FINAL RESOURCE CONSERVATION AND RECOVERY ACT FACILITY INVESTIGATION
WORK PLAN ZONE L CNC CHARLESTON SC
11/27/1996
ENSAFE

Subj: SUBMITTAL OF ZONE L RCRA FACILITY INVESTIGATION WORKPLAN
CHANGES

**FINAL ZONE L
RCRA FACILITY INVESTIGATION WORK PLAN
RESPONSE TO REGULATORY COMMENTS**

**Response to South Carolina Department of
Health and Environmental Control
Comments For the Zone L RCRA Facility Investigation Work Plan,
Dated October 18, 1995**

FIGURE 2-23
 AOC 504-BB: RAILROAD SYSTEM
 VESSEL BILGE WATER UNLOADING
 PROPOSED SAMPLE LOCATIONS

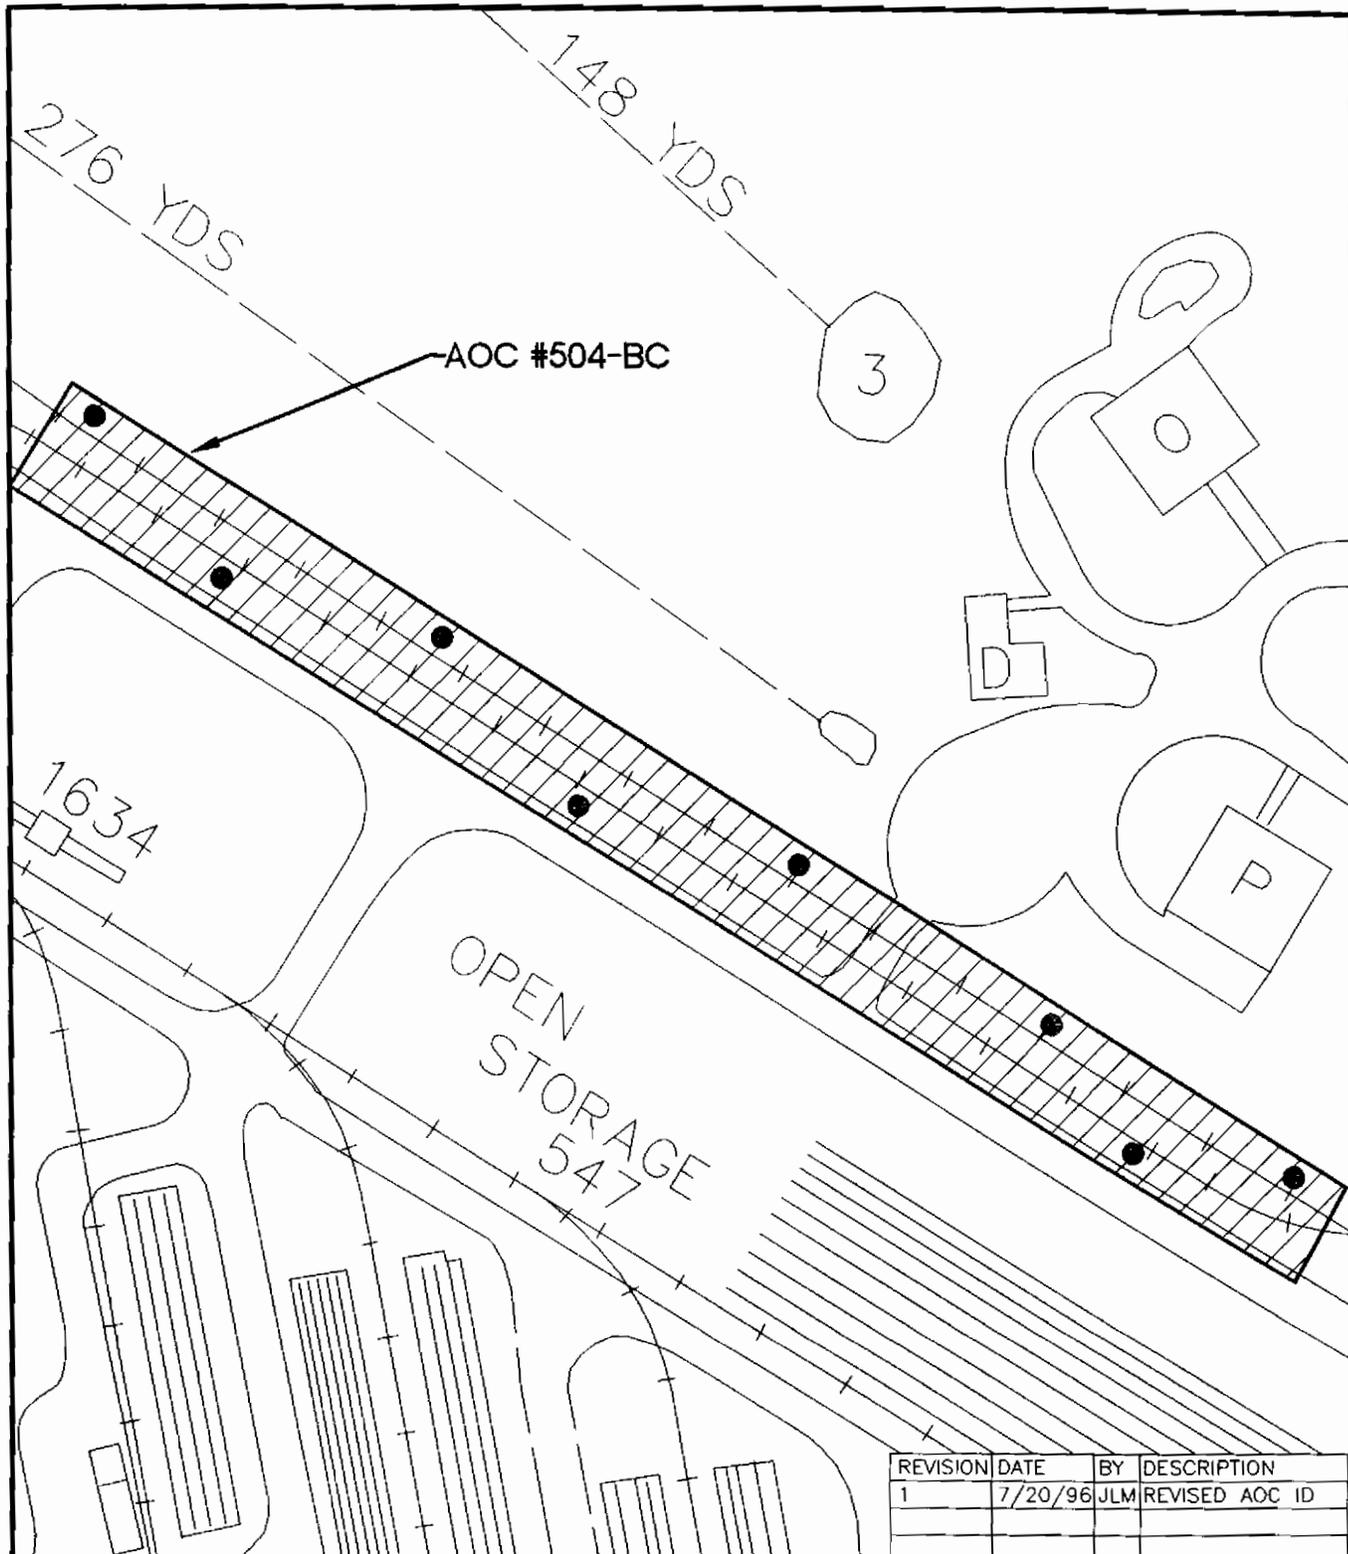
The third bullet on page 2-42 notes that AOC-AP is being investigated under the Zone A RFI Workplan. This bullet does not state whether or not additional sampling is proposed at this site, however according to Figure 2-23, eight additional soil samples are proposed to be collected in this area. The workplan should be revised to state explicitly that sampling is proposed at this site.

Figure 2-23 indicates that sampling has been performed under the Zone A Work Plan. The work plan has been revised to explicitly state that additional sampling will be performed in conjunction with the Zone A RFI at SWMU 2.

FIGURE 2-24
 AOC 504-BC: RFI RAILROAD SYSTEM
 COAL/CONTAINER CAR STORAGE AREA
 PROPOSED SAMPLE LOCATIONS

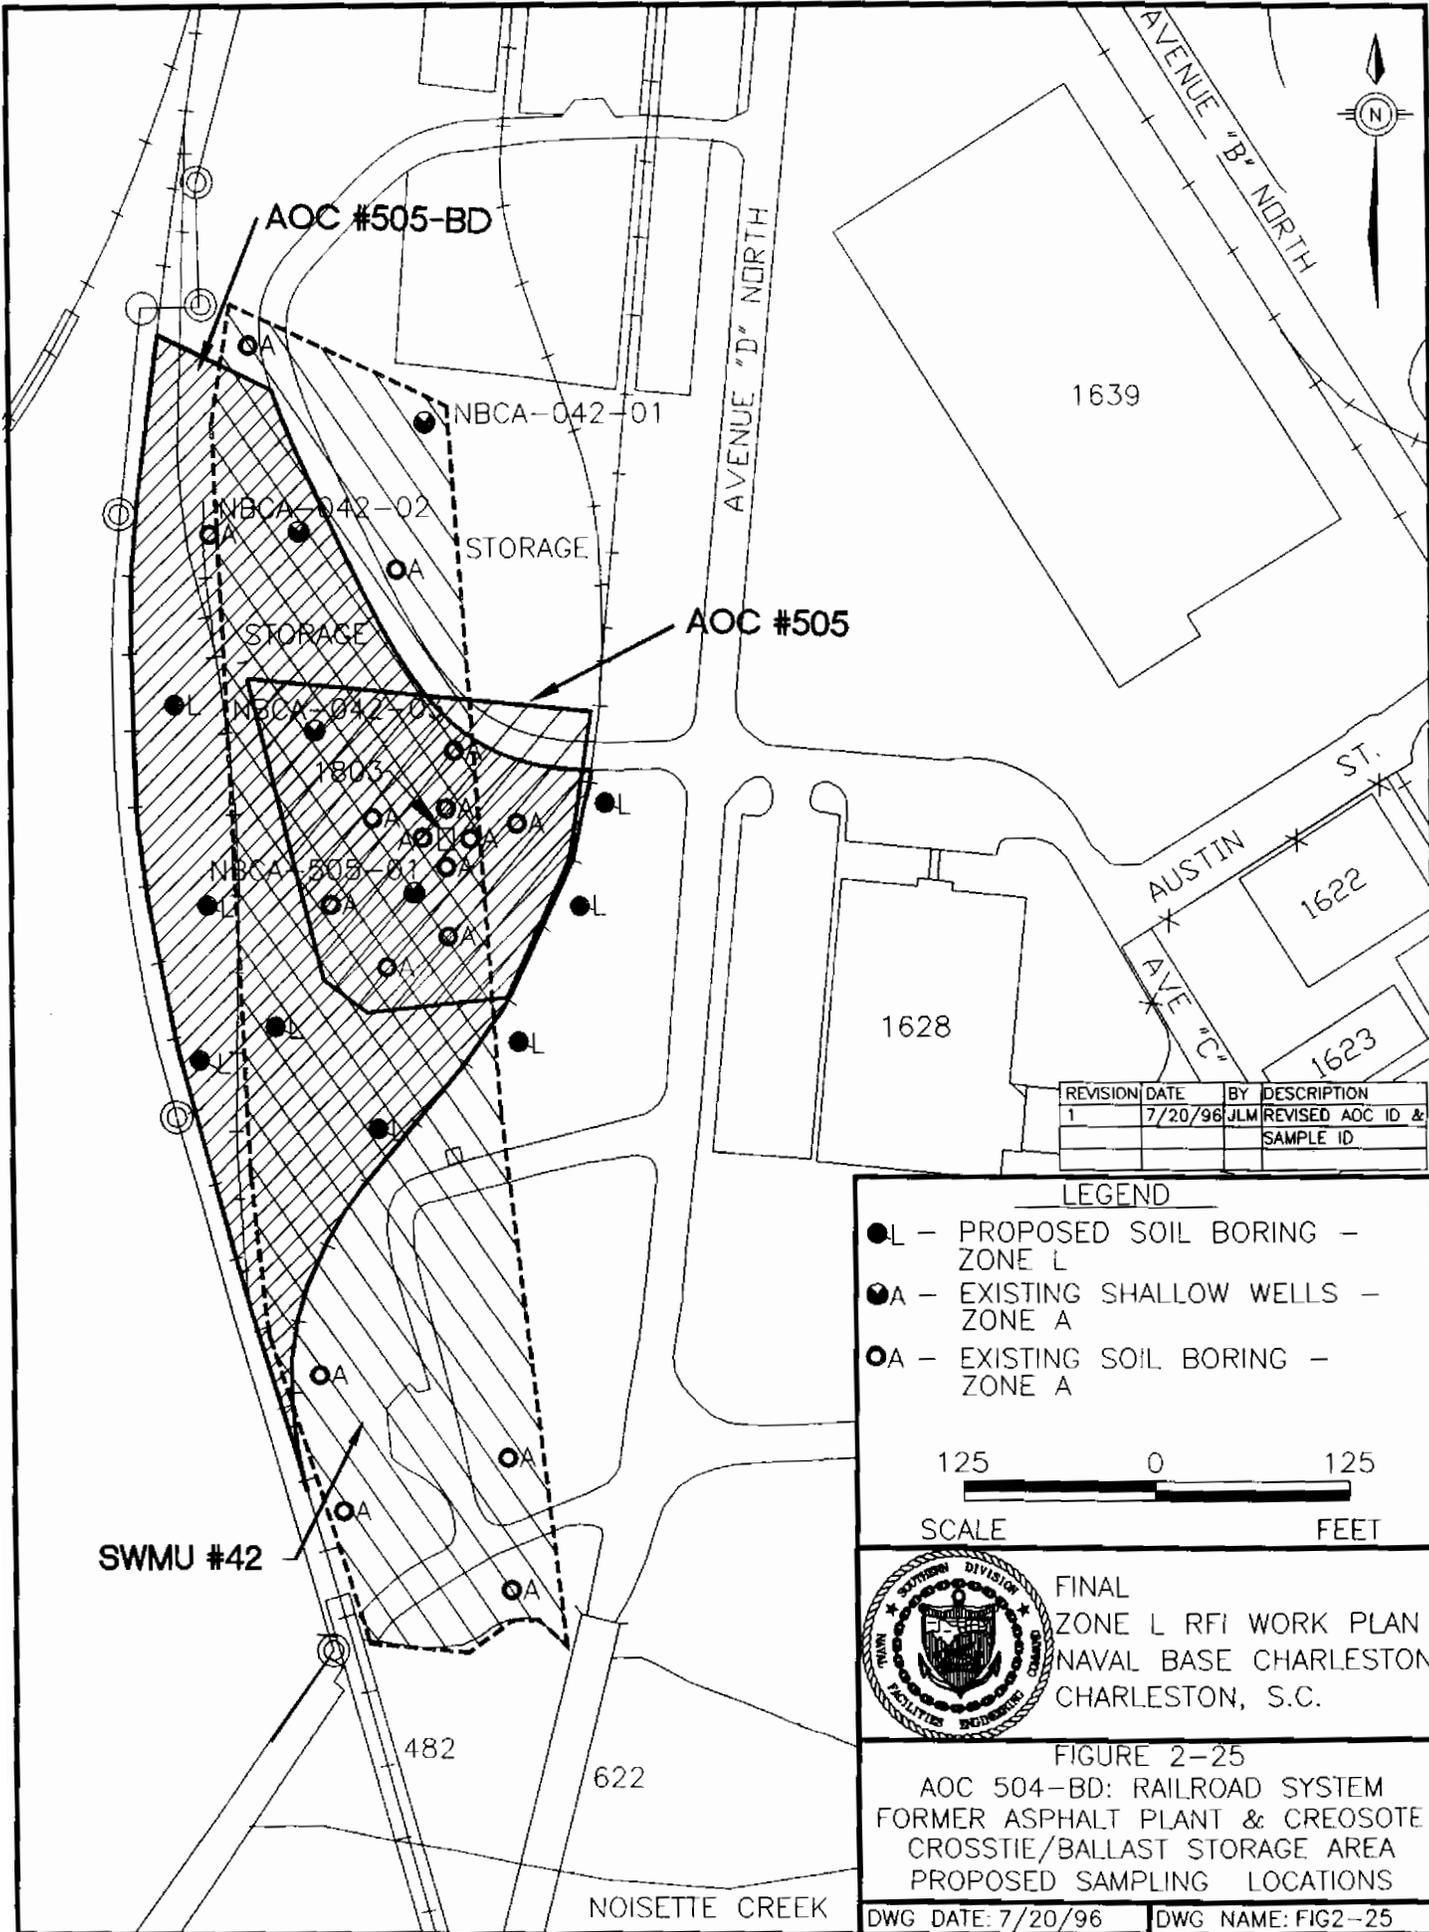
Figure 2-24 depicts previous sampling locations and proposed sampling locations in the vicinity of the Defense Reutilization and Marketing Office (DRMO). However, due to the size of the symbols used, it is nearly impossible to distinguish the previous sampling locations from those that are proposed in this workplan. Figure 2-24 should be revised to clearly indicate previous sampling locations from those that are proposed. It is recommended that symbols similar to those used in Figure 2-23 be incorporated into Figure 2-24 to make this distinction.

Figure 2-24 has been revised to ensure the size of all symbols are consistent with other drawings and can be easily differentiated.
